## Product Change Notice (PCN)

**PCN Number:** PCN-0451156R-01

**Product(s) Affected:** PJ-039A, PJ-039B, PJ-039AH, PJ-039BH

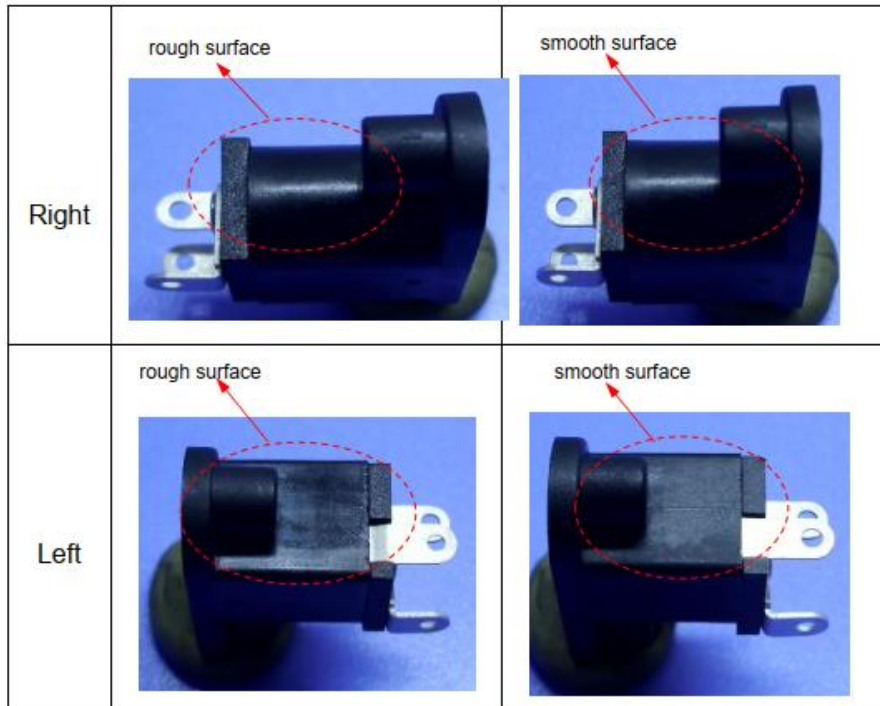
**Description of Change:** Thickness of pin 2 changed from 0.2mm to 0.25mm. Aesthetic changes as shown in below comparisons:

Current version	New version
Outlook		
Front	<p>without chamfer</p> 	<p>with chamfer</p>

<p>Back</p>	<p>cave marking location</p>  <p>smaller</p> <p>cave marking location</p>	<p>cave marking location</p>  <p>thicker</p> <p>cave marking location</p>
<p>Top</p>	<p>with injection mark</p>  <p>thickness of pin#2 is 0.2mm</p>	<p>without injection mark</p>  <p>thickness of pin#2 is 0.25mm</p>
<p>Bottom</p>	<p>without injection mark</p> 	<p>with injection mark</p>
